Victorian Electricity Distribution Businesses 2021 - 26 Revenue Determinations

AER Public Forum presentation and response to issues paper

22 April 2020

CCP17

Figure 10 Difference between proposed opening and closing RAB per customer – 1 July 2021 to 30 June 2026 (\$real June 2021)

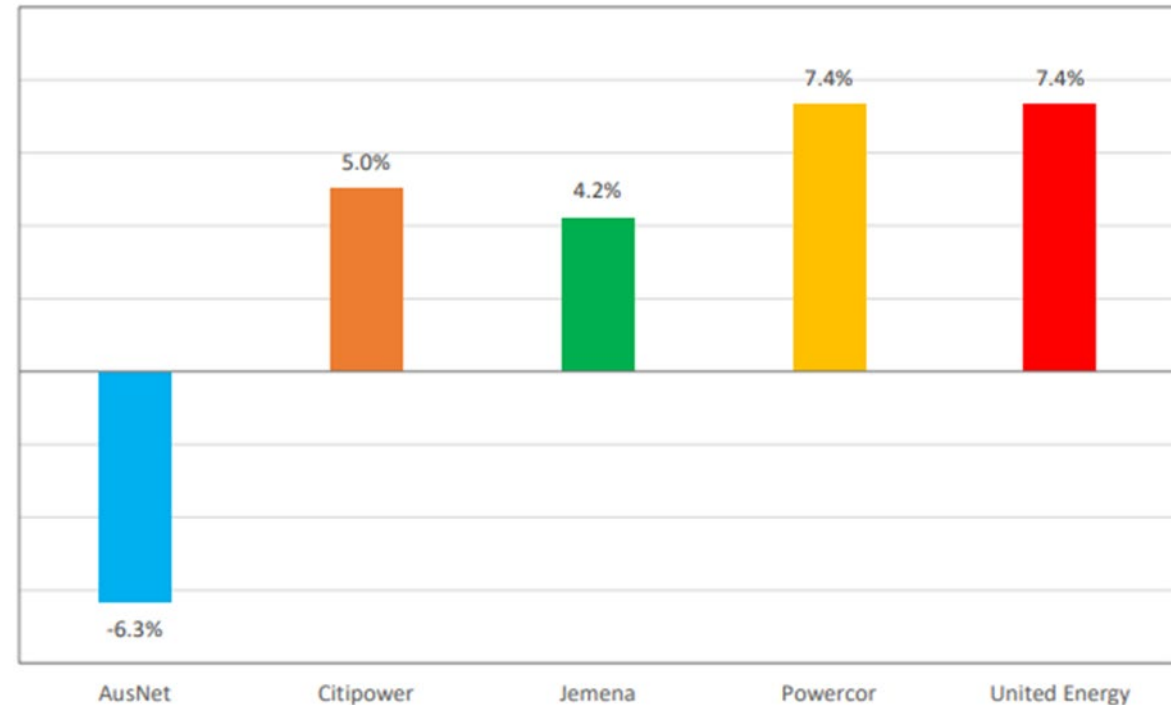
However, the level of investment, leading to the increase in the regulated asset base per customer (for all but AusNet), raises real risks of significant prices in the future if and when the allowable return on assets increases.

In our assessment, we look for evidence where utilities have considered a revised risk position, the application of innovative solutions and the fact that 'not every NPV positive project needs to go ahead' in order to respect the customers' desire to restrict future price rises.

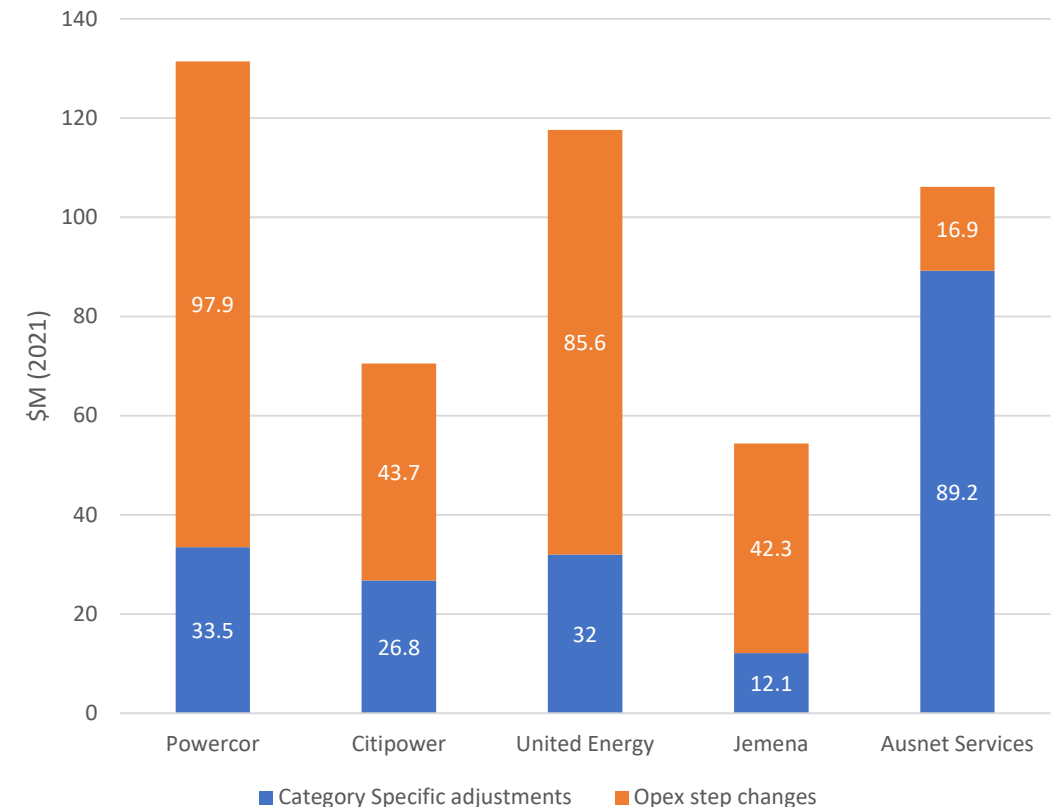
There are some notable issues in the approaches across businesses, such as:

- CPU choosing to reclassify some minor line repex as repairs (\$18 – 26M)
- The cost to undergo operational changes to meet cybersecurity obligations can vary significantly based on current organisational arrangements
- Some AMI costs are being transferred to SCS
- Most utilities continue to invest in ICT cloud services. The capital savings from this action are not clearly evident as ICT capex reductions.
- REFCL systems require ongoing attention, such as tuning, representing ongoing costs of up to \$13M in Powercor’s case.
- AusNet seeking a significant GSL adjustment of \$46M, noting the in the RIN as ‘payments for failure to meet GSLs’.

CCP recognises that many of these changes result from legislative and industry requirements, although we seek further clarification that some of the proposed adjustments are valid, efficient and demonstrably a recurring operating cost of the business. (see next slides)

Figure 4.3 DNSP opex multilateral partial factor productivity indexes, 2006–18

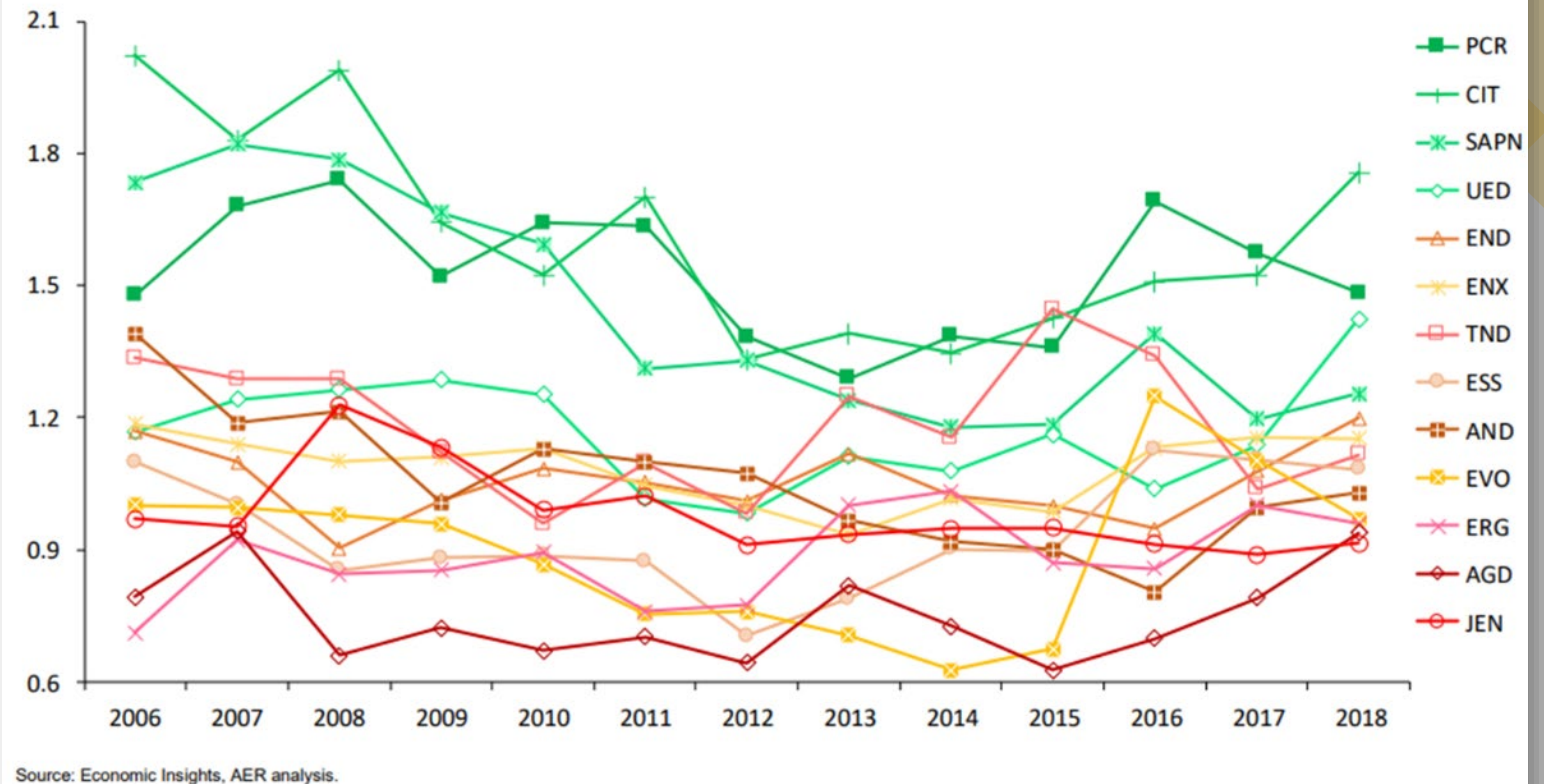
Opex multilateral partial factor productivity (MPFP) from AER benchmarking report 2019 shows:

- JEN & AusNet are in the lower range re opex efficiency, though improving over recent years.
- 'CPU' group are in 'best 4', though UE MPFP declining.

Leads to questioning whether base year is efficient for all Victorian DNSP's

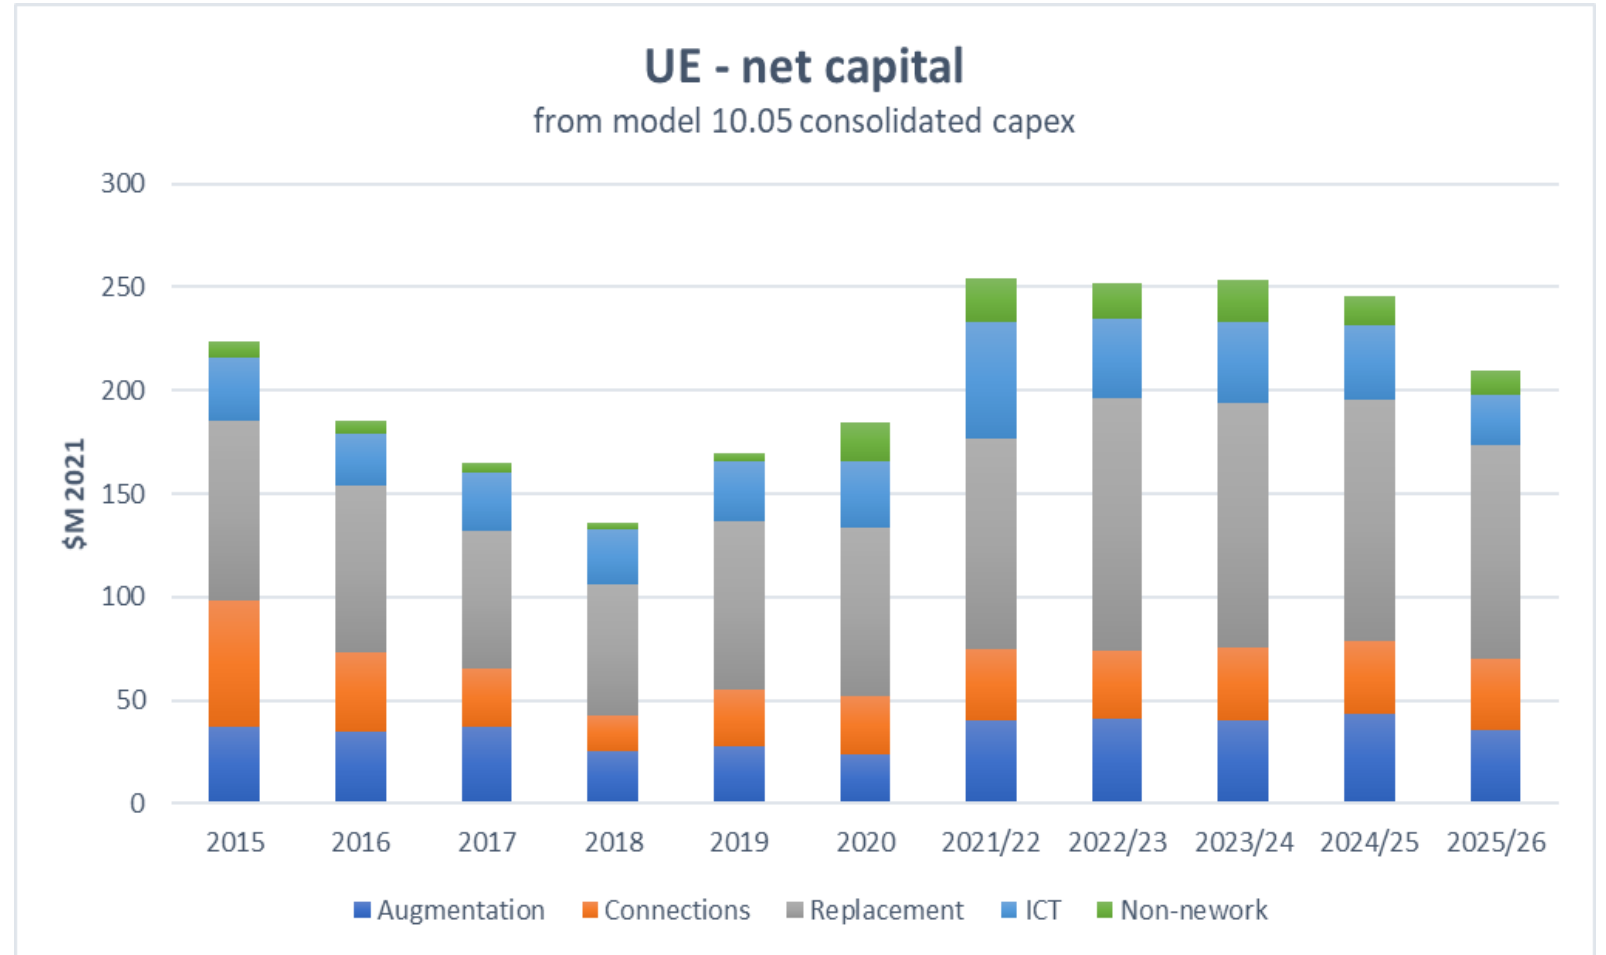
Again, Capex proposed is higher than current period across every category.

Do the drivers, observations and engagement outcomes support this pattern ?

Was the underspend from the current allowance genuine efficiencies, or has some work been carried forward ? This is not clear.

Increases to:

- Repex (mainly poles)
- Augex (solar enablement + growth)
- ICT – Solar enablement
- Environmental compliance
- Building refurbishment

United Energy Augmentation Capex
as incurred / forecast - from Model 6.01 (augex)

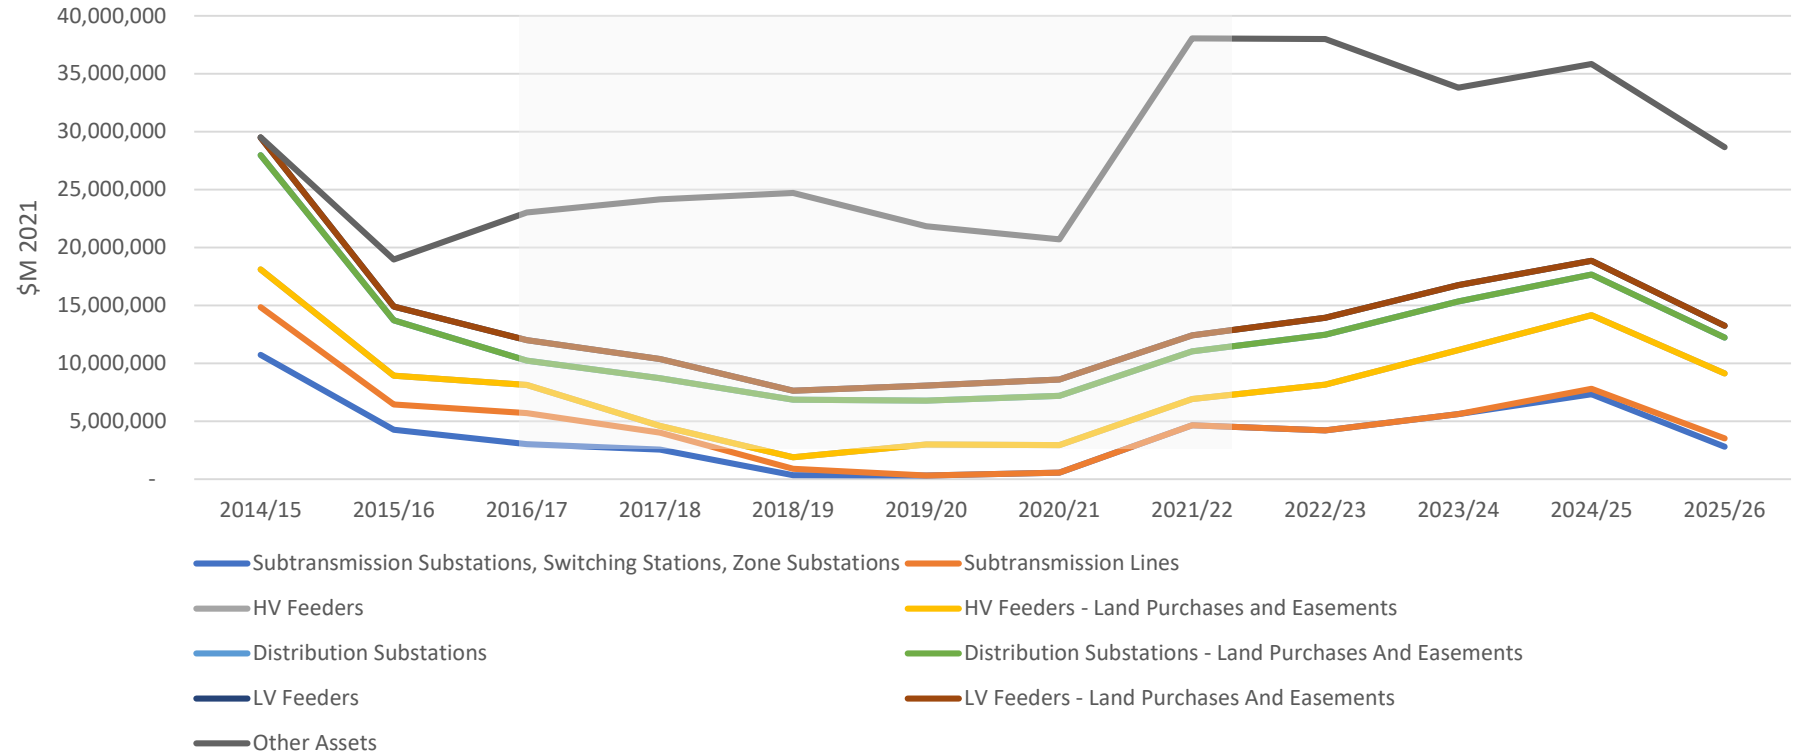
Observation –
Augmentation proposed is higher than current period across every category. Do the drivers, observations and engagement outcomes support this pattern ?

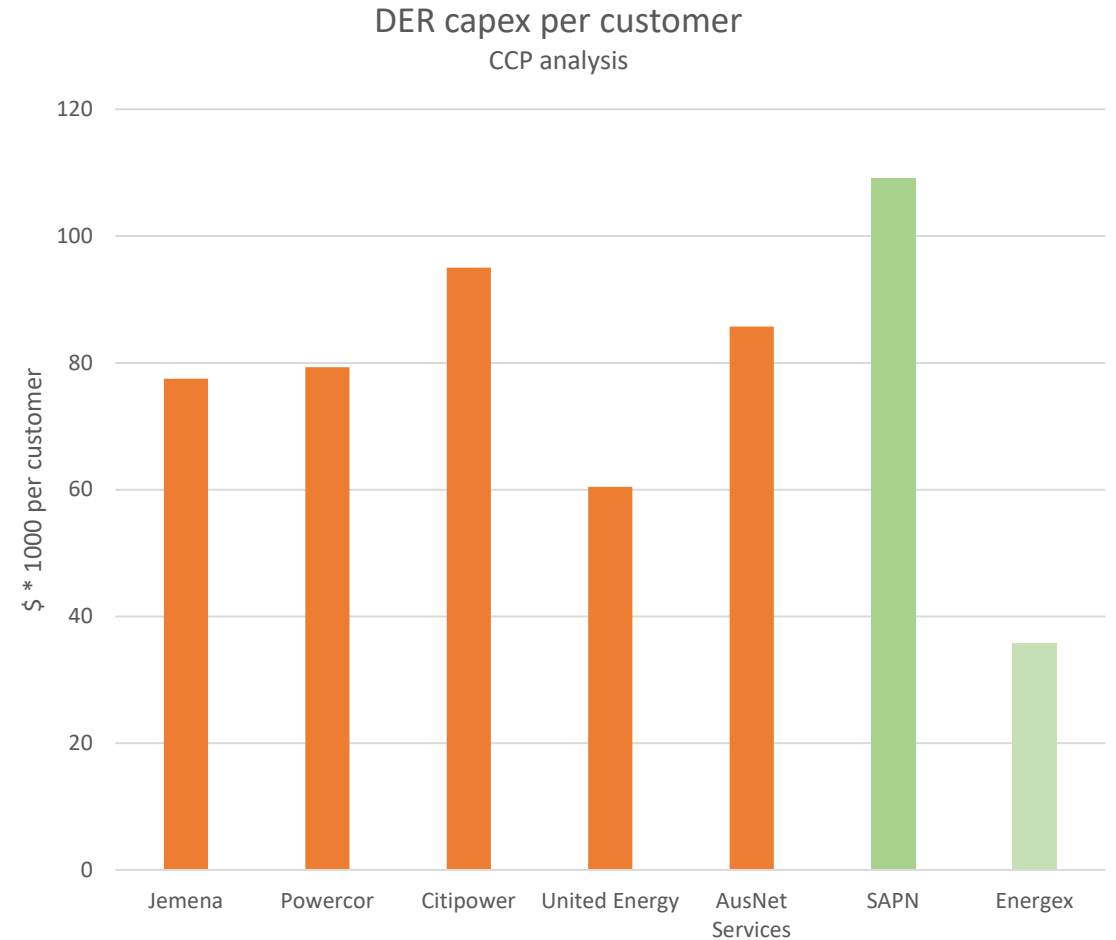
CCP carried out some basic analysis to consider the investment in solar enablement per customer (all customers).

Given the limitations of the broad analysis, it suggests that the amounts proposed by the Victorian companies compares reasonably with other states with high penetration of PV (SAPN – high PV levels, and Energex who are benefiting from a legislated voltage reduction).

We suggest greater scrutiny of the CitiPower proposal, given our expectation that the nature of the CitiPower distribution area is not conducive to large residential rooftop PV systems.

Depreciation allowance as a proportion of opening RAB

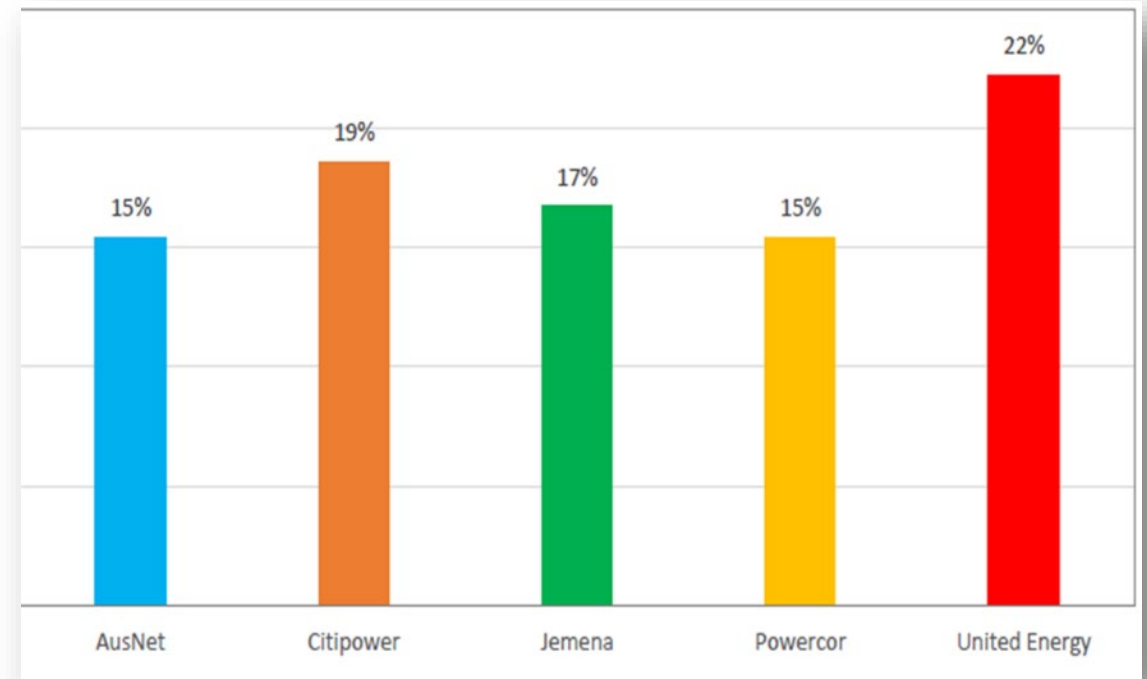
Are Consumers getting good value for these accelerated depreciation elements?

CCP17 is not convinced by the large time changes for some assets by some businesses, eg devices currently depreciated over 45-50 years being depreciated over 10 years, or 24 year current life to 5 year. How do the proposed depreciation lives relate to the AER “roll forward model?”

Solar enablement depreciation needs further justification

Where reducing lives of assets makes sense, can the adjustment be made over 2 periods, rather than one?

Figure 12 Proposed EBSS carryovers and (\$million, June 2021) and proposed CESS revenue increment (\$ million, June 2021)

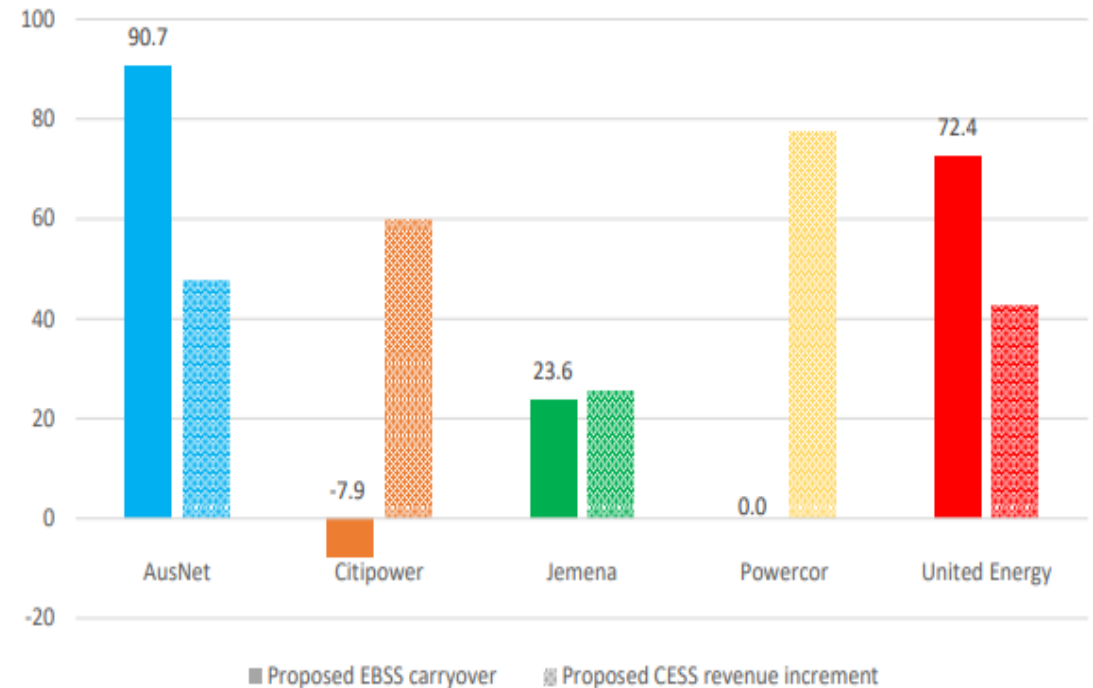
This diagram poses several questions for consumers:

1. How can the leaders in the electricity distribution efficiency benchmarks continue to deliver such significant efficiencies?
2. How do the efficiencies delivered sit with increased opex and capex in the proposals?
3. As per our earlier slide - Every utility is proposing a significant *capital efficiency carryover*. Underspensing an allowance then asking for an increased capital allowance in a subsequent period draws consumer interest, where we ask the question 'if it is so important, why not get on with it now ?'.
